**Panamera Climate Control Settings are not Retained with Memory Settings**

**Vehicles Affected**

Models	Model Year	Model Type	VIN Range	Vehicle-Specific Equipment
Panamera	As of 2017 up to 2023	971	N/A	N/A

Figure 1

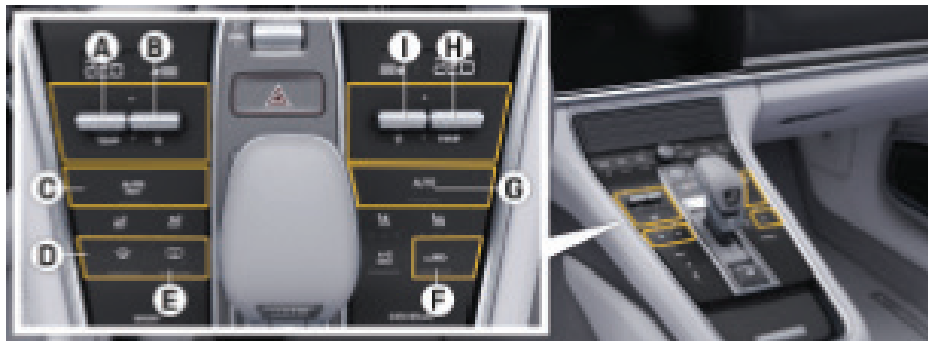
Customer complains the climate control / air-conditioning system settings are not retained through the driver memory or comfort memory system in the car.

Air conditioning and climate control settings are no longer part of driver and comfort memory settings as of A/C control unit software version 1751 and higher. As of SW 1751, the system only provides retention of Last Mode settings.

This is an intentional change in operating concept, and customers may observe this change following a software update or control unit replacement. It is not permitted to recode or retrofit this function.
